**From:** Brian Peterson  
**Sent:** Thursday, February 4, 2021 11:46 AM  
**To:** Anya Grahn  
**Cc:** Colleen Willger; Judy Johnson  
**Subject:** 2200 Homestead Housing-Design Review  
**Attachments:** 2200 Homestead\_BP design comments 02-02-21.pdf

# Design Review Comments 2200 Homestead

Brian Peterson 02-02-21

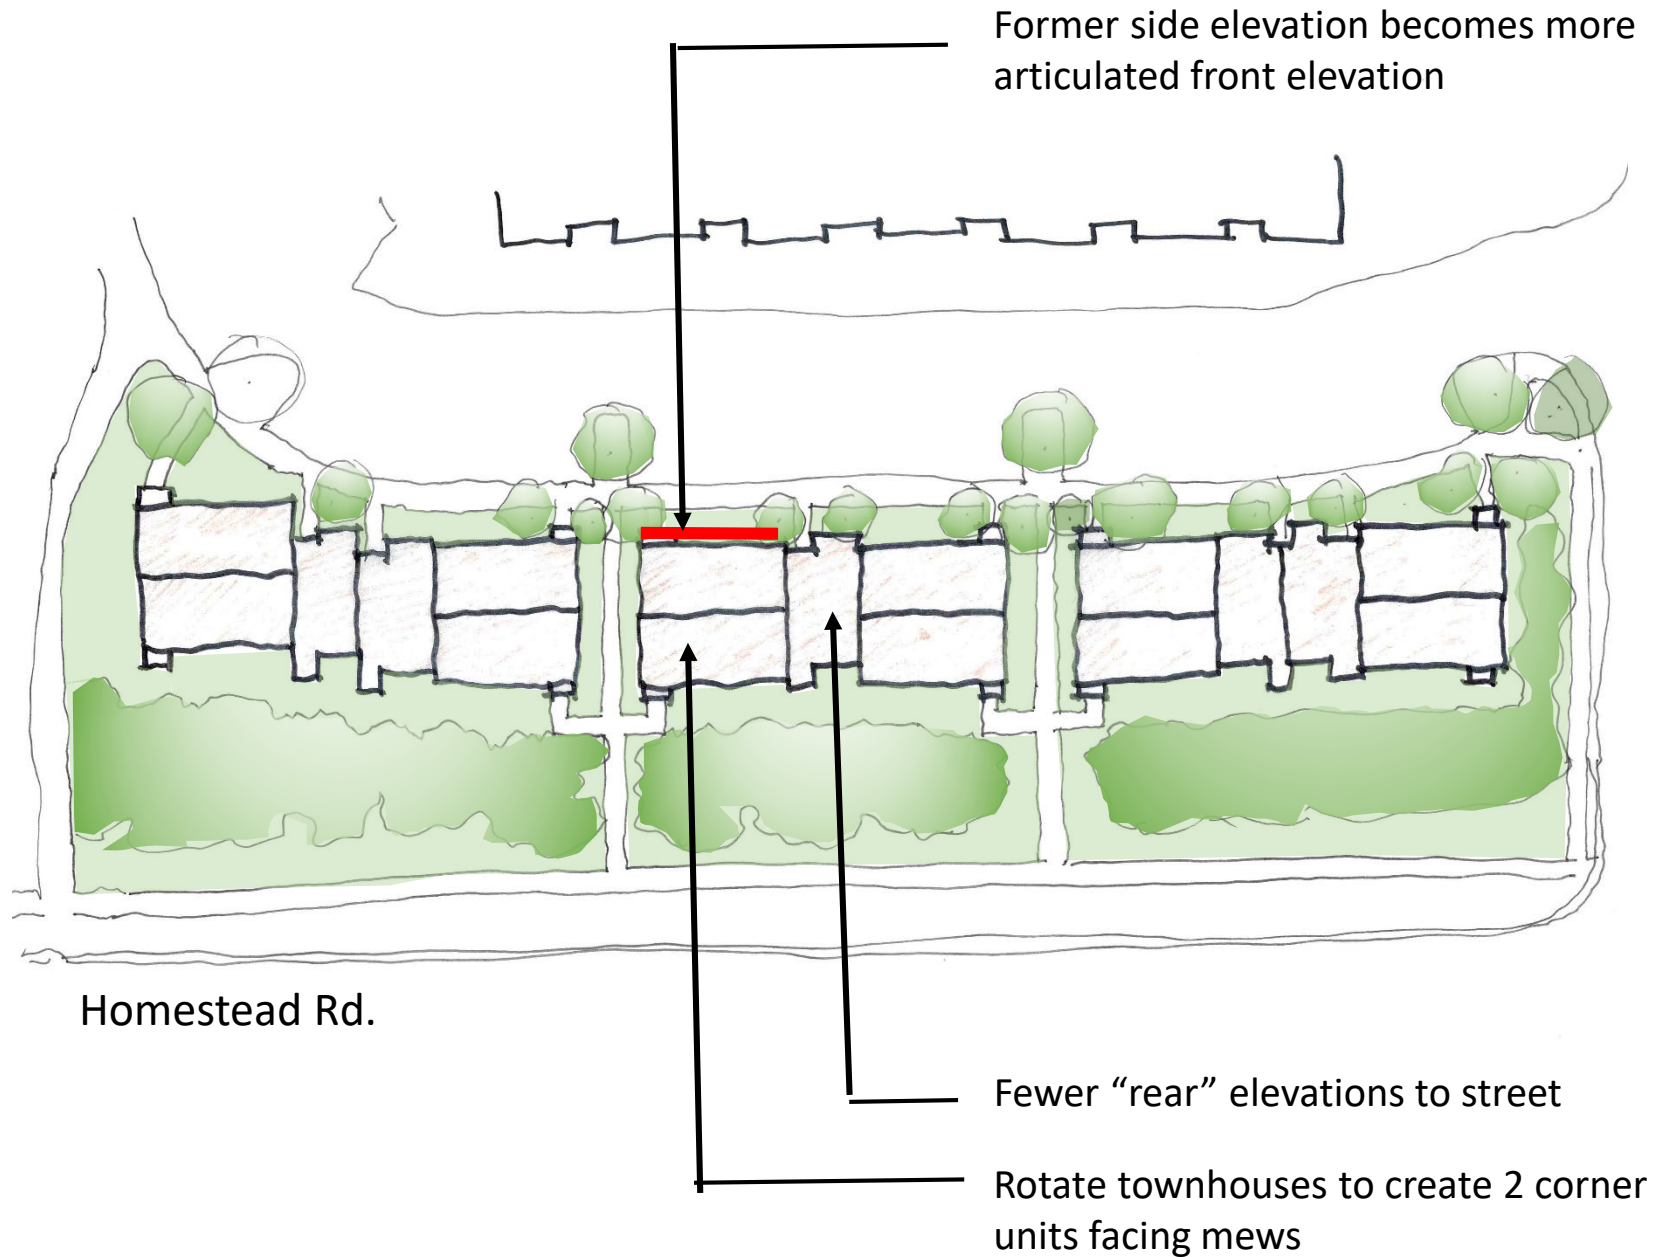
1. Pedestrian connections: suggested adding a few sidewalk and crosswalk connections (shown red on sketch) I thought having a sidewalk on the east side of the entrance drive provided a better pedestrian character and could link up to the future greenway trail on the Bridgepoint property and offer another way to walk through the sites. I also thought it worth exploring another east/west sidewalk connection to Bridgepoint near the entrance drive. We'll have to check with Eric and Cameron to see if this is something they would desire as well.

Future greenway & connections

Provide crosswalks and connect to Bridgepoint sidewalks

Provide sidewalk along entry street

Provide crosswalk and sidewalk tie-in to Bridgepoint
